**SUNDRY NOTICES AND REPORTS ON WELLS**  
**Do not use this form for proposals to drill or to re-enter an abandoned well. Use Form 3160-3 (APD) for such proposals.**

COG Operating LLC respectfully requests approval for the following changes to the original approved APD.

**RIVERWALK FEDERAL COM #503H**

**Type of Action:** APD Change

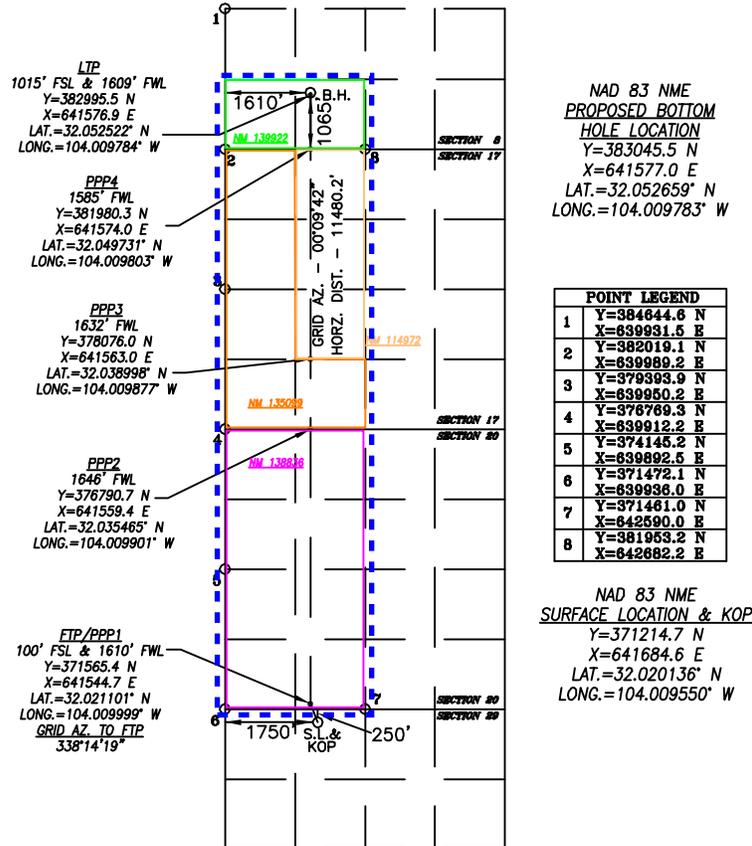
BHL Change From: 1270' FSL & 1980' FWL Section 8. T26S. R29E.  
To: 1065' FSL & 1610' FWL. Section 8.T26S. R29E.

Dedicated Acres: From: 360  
To: 719.78

UL	Section	Township	Range	Lot	Ft. from N/S	Ft. from E/W	Latitude	Longitude	County
<b>N</b>	<b>8</b>	<b>26-S</b>	<b>29-E</b>		<b>1065 FSL</b>	<b>1610 FWL</b>	<b>32.052659°N</b>	<b>104.009783°W</b>	<b>EDDY</b>

Dedicated Acres <b>719.78'</b>	Infill or Defining Well <b>Defining</b>	Defining Well API <b>30-015-53824</b>	Overlapping Spacing Unit (Y/N) <b>N</b>	Consolidation Code
Order Numbers.			Well setbacks are under Common Ownership: <input checked="" type="checkbox"/> Yes <input type="checkbox"/> No

Project: ATLAS PROSPECT (DBW)  
 Site: RIVERWALK FEDERAL PROJECT (ATLAS 2629)  
 Well: RIVERWALK FEDERAL COM #503H  
 Wellbore: OWB  
 Design: PWP1  
 GL: 2922.0  
 KB=26 @ 2948.0usft

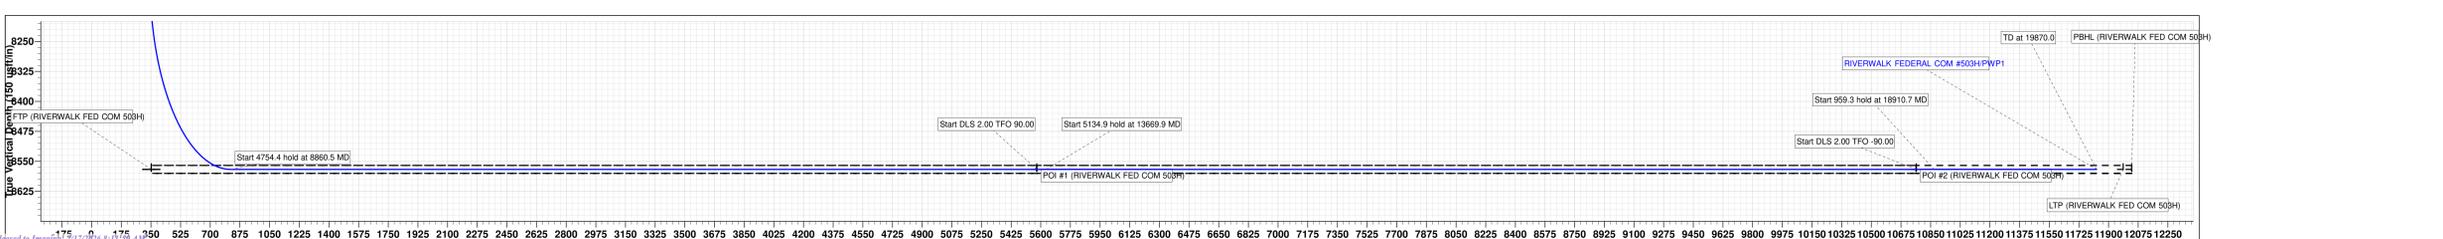
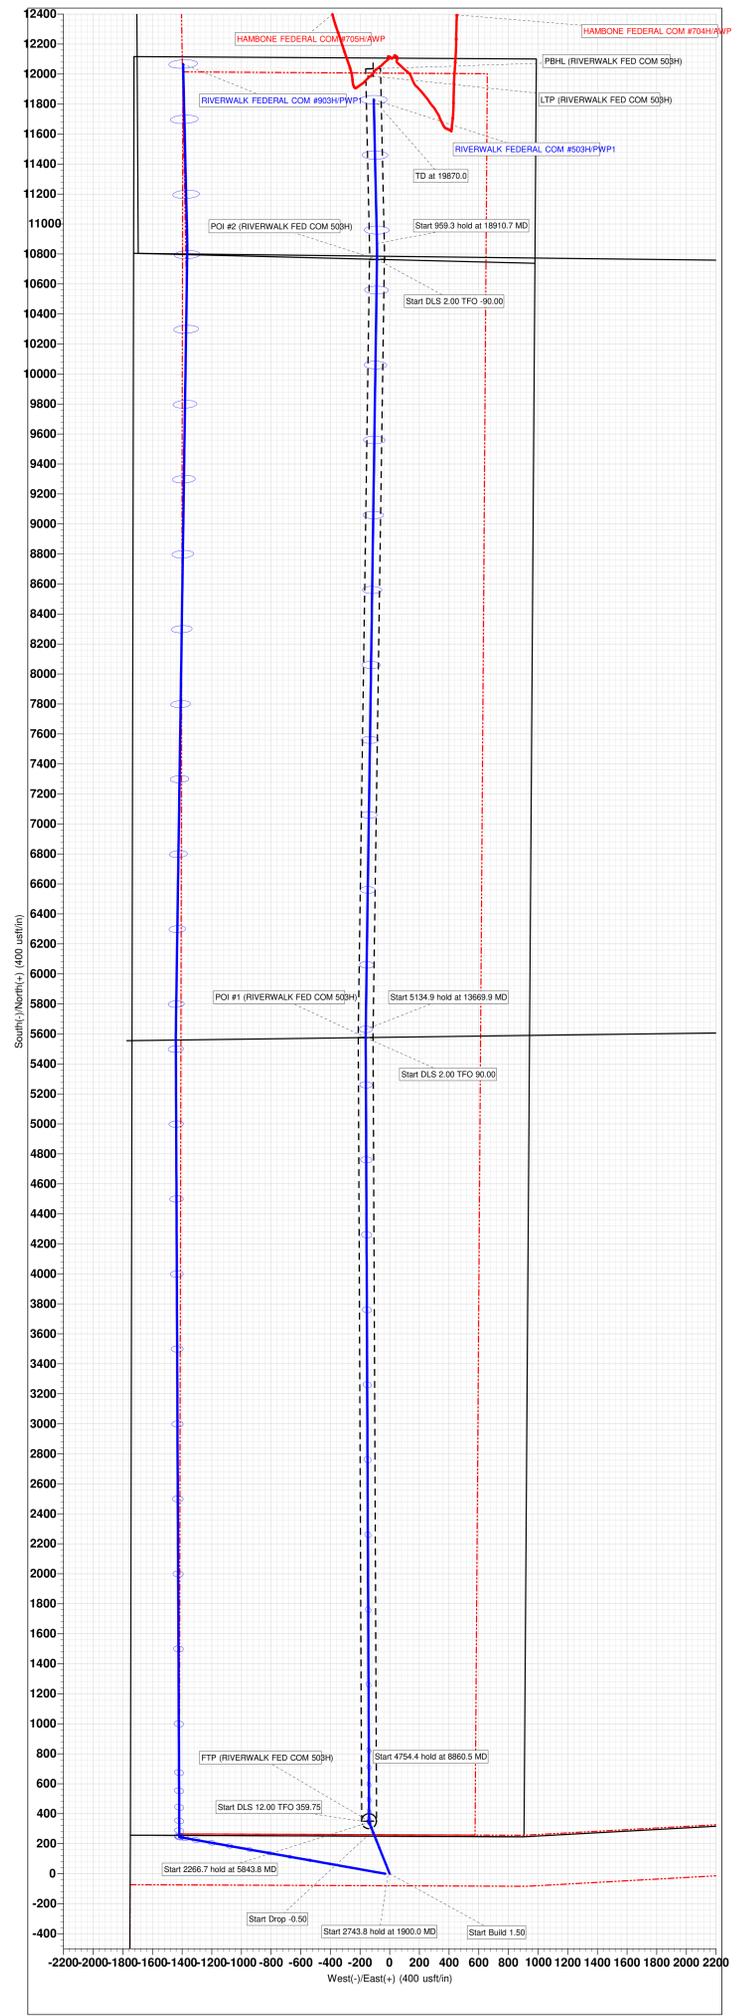
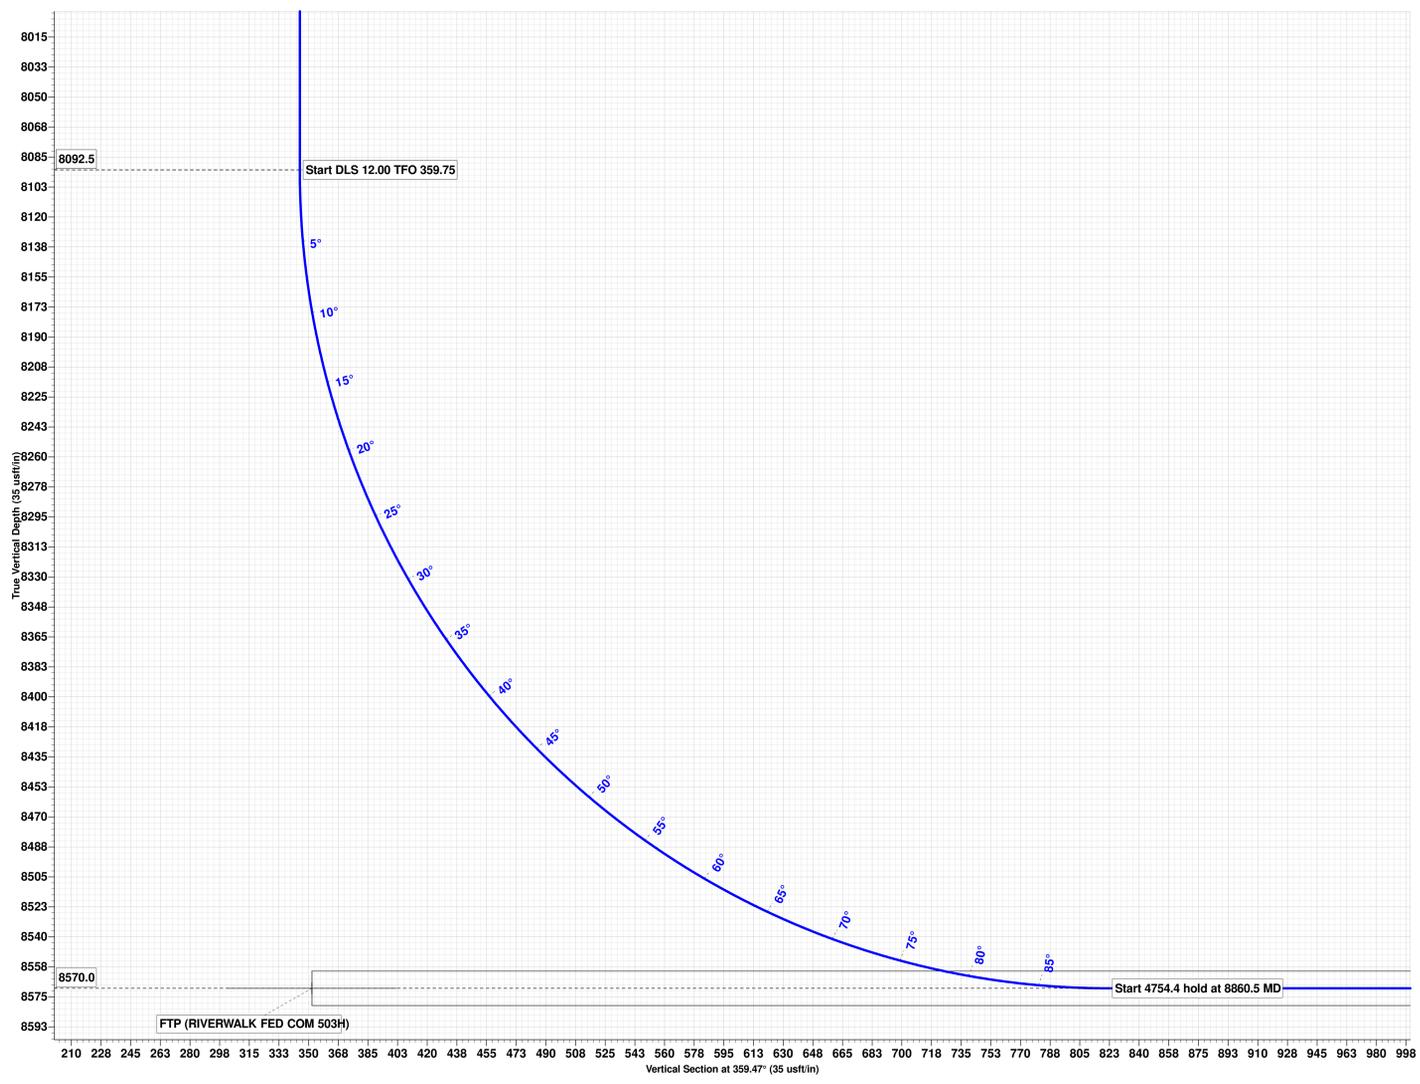
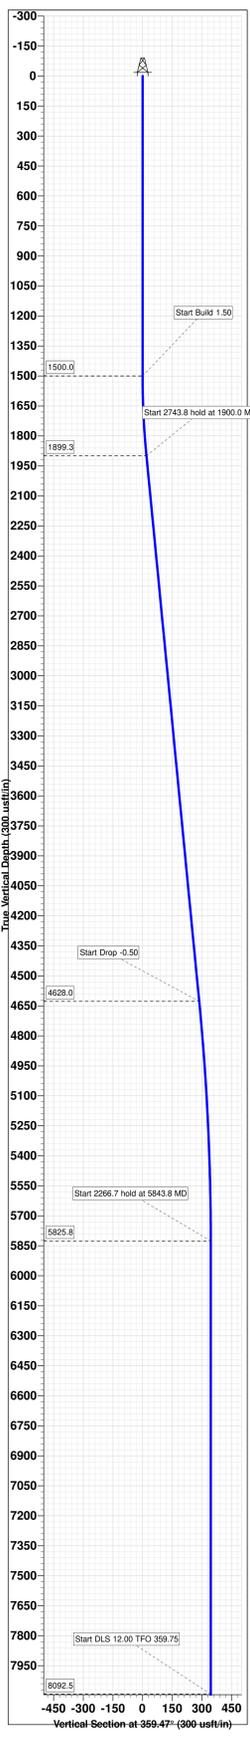
Casing and Cement Changes: The proposed changes reflect downsizing the surface, intermediate and production open hole sections to 14-3/4, 9-7/8 and 6-3/4 respectively. Cement blends are the same as the approved APD, and volumes have been adjusted to reflect the change in wellbore design.

Drill 6-3/4 hole to TD of 19,870. Run and cement 5-1/2 20# P110-CY TXP-BTC from 0-7,500 and 5-1/2 20# P110-CY W441 from 7,500-19,870 (crossover 500 inside intermediate casing for cement bond tie in)  
220 sacks of 11.0 ppg lead (3.22 ft<sup>3</sup>/sack yield and 9.32 gal/sack mix water)  
940 sacks of 13.2 ppg tail (1.48 ft<sup>3</sup>/sack yield and 7.49 gal/sack mix water)
